CITY OF CAMBRIDGE, MASSACHUSETTS

PLANNING BOARD

NOTICE OF DECISION

Case Number:	293
Address:	79 JFK Street
Zoning:	Residence C-3 / Harvard-Radcliffe-Lesley Institutional Use Overlay District
Applicant:	President and Fellows of Harvard College, c/o Harvard Planning & Project Management 1350 Massachusetts Avenue, Suite 573, Cambridge, MA 02138
Owner:	President and Fellows of Harvard College Massachusetts Hall, Cambridge, MA 02138
Application Date:	August 5, 2014
Date of Planning Board Public Hearing:	October 7, 2014 and continued to November 25, 2014
Date of Planning Board Decision:	November 25, 2014
Date of Filing Planning Board Decision:	January , 2015
Application:	Request for Project Review Special Permit (Section 19.20) to permit the construction of three institutional building additions and redevelopment of the courtyard at the Harvard Kennedy School Campus.
Decision:	GRANTED, with Conditions

VIEW OF BELFER CENTER ENTRY - EXISTING

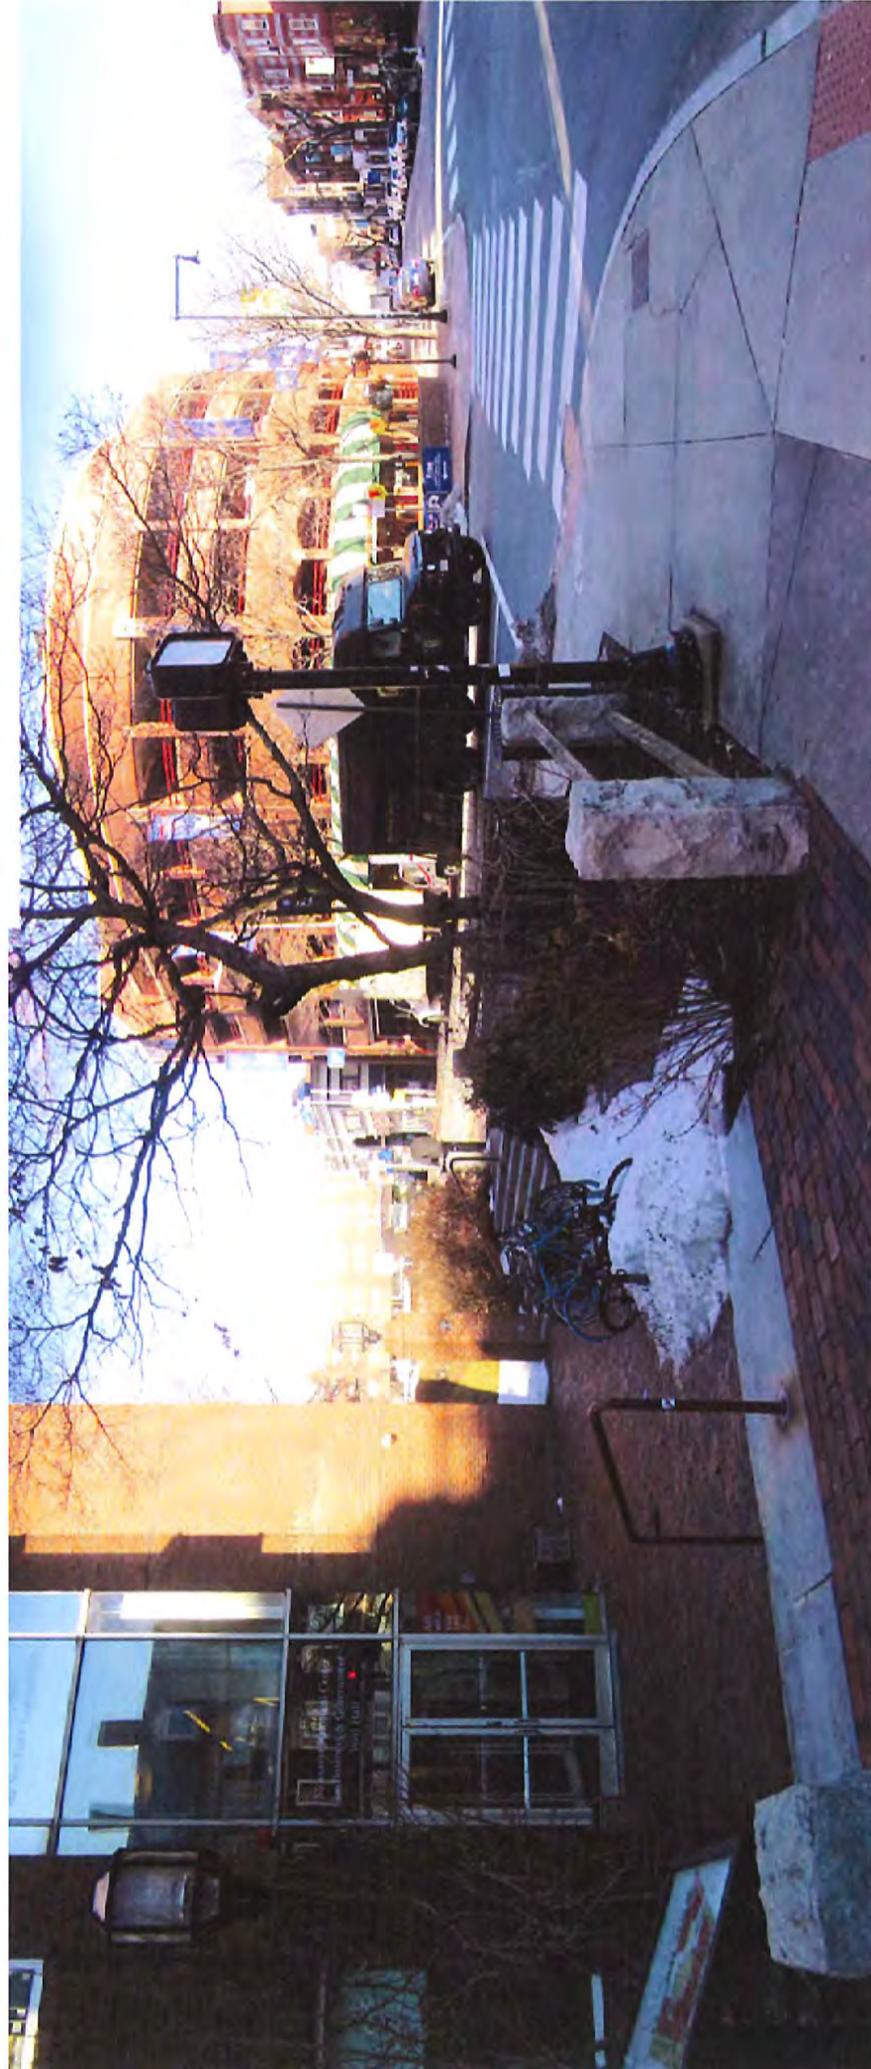
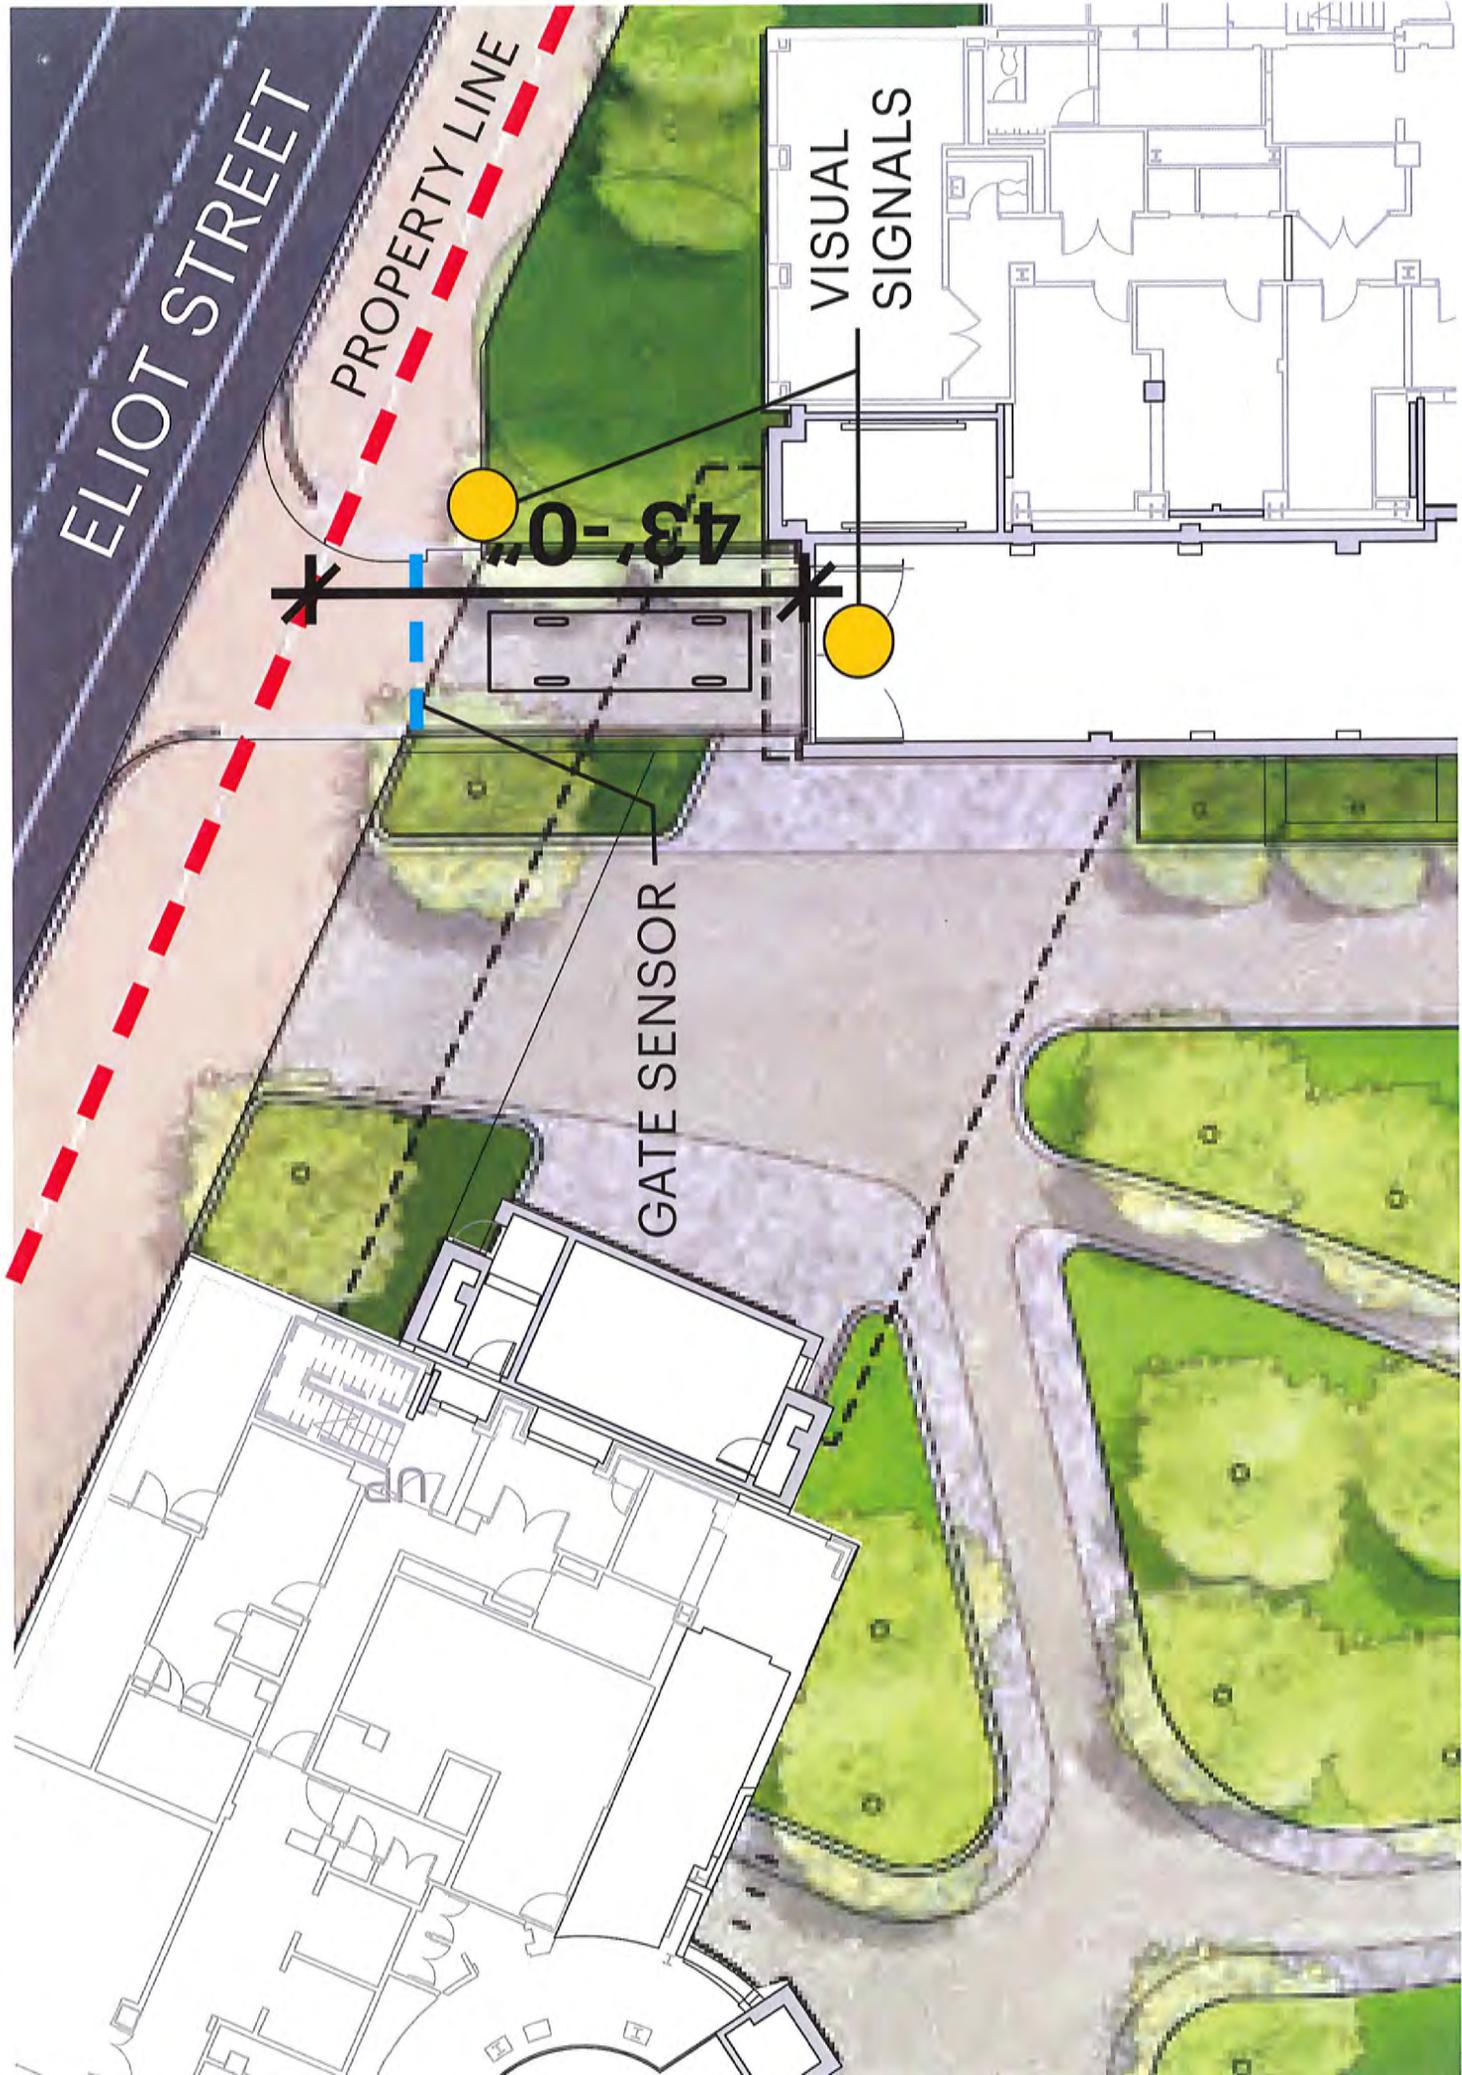
In response to comments received from both the public and the Planning Board, the design of this entry area has been modified to incorporate additional landscape elements at either end of the entry stairs and within the central portion of the stairs (See Attachment 1-2). To address safety concerns, hand rails have been placed at the outer edges of the stairway sections. In addition, brick paving is proposed for the sidewalk directly adjoining the entry area. The proposed condition will significantly improve the public realm at this location by increasing the width of a very active sidewalk at this corner.

DOCK MANAGEMENT - UNDERGROUND LEVEL

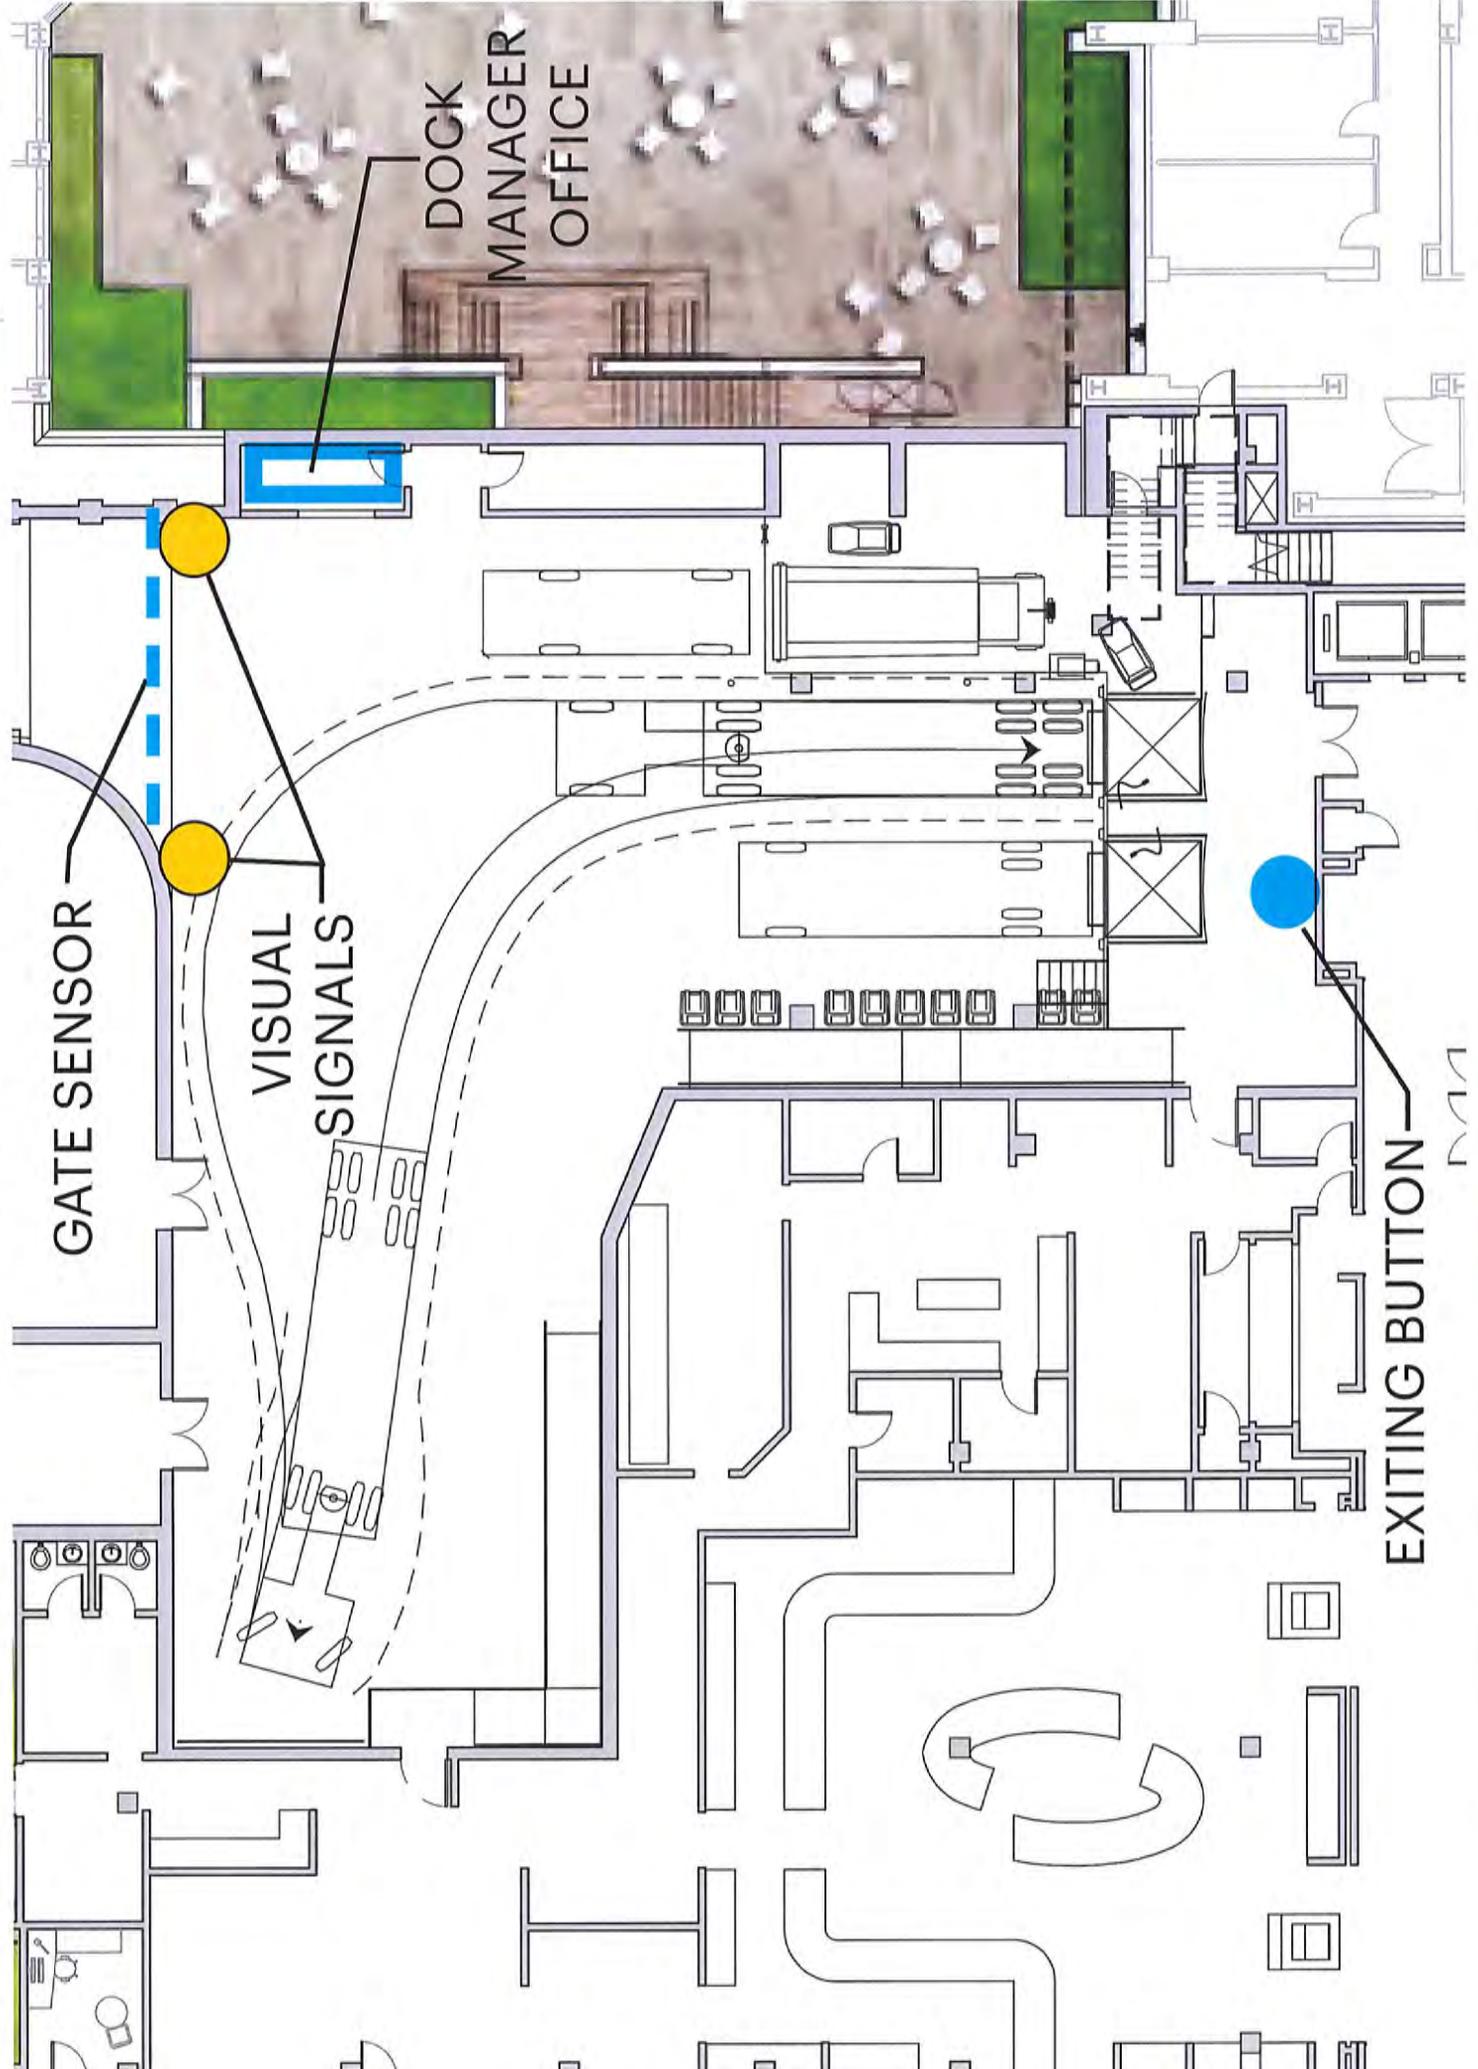
The proposed loading facility will be located beneath the raised courtyard and will be accessed via a dedicated entry driveway from Eliot Street (See Attachment 2-1). The minimum distance from the HKS property line to the loading dock door is 43 feet, permitting arriving vehicles to pause briefly on HKS property without interfering with pedestrian, bicycle or vehicle movement along the sidewalk and Eliot Street.

GATEWAY BUILDING - DESIGN ITERATIONS

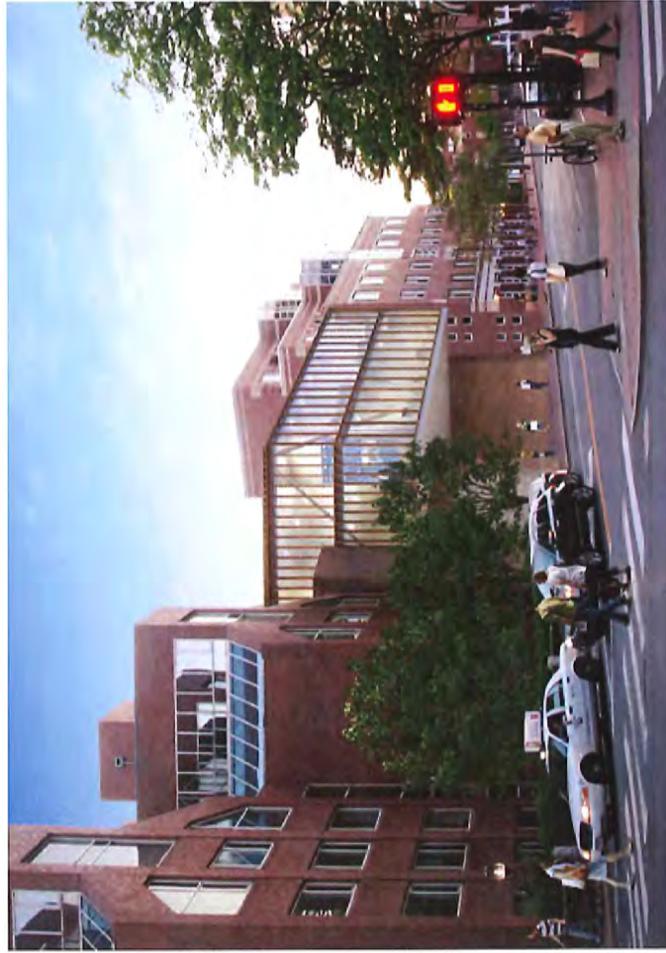
HKS and its design team have studied many possible approaches to the architectural treatment of the proposed connector buildings (See Attachment 3-1). The design of the Gateway Building, as initially presented in the Special Permit application, incorporated key design modifications from the building's earlier conceptual studies including stepping back the building's upper level to reduce its apparent massing, the introduction of a brick cornice to strengthen the visual relationship between the addition and the existing Taubman and Belfer buildings, and a simplification of the proposed façade treatment.
